DATE: 09.29.2015
TO: ProTrak
FROM: Bill McDow
Transportation Planning

■ **DREAMS PARKING LOT [TRC Plan Review]**

↻ Initial Review Note ↻

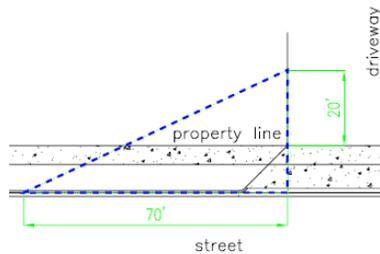
- Revise all sheets to accurately illustrate the existing conditions on and surrounding this parcel. Show all adjacent traffic signs, lane configurations, traffic control devices and pavement markings on the site inventory plan. Please refer to the Technical Standards and Specifications Manual (link is below) Ch. VII C.1.a.2. for specific information and distance requirements. Contact Traffic Engineering at 341-7888 if you need assistance locating these elements.
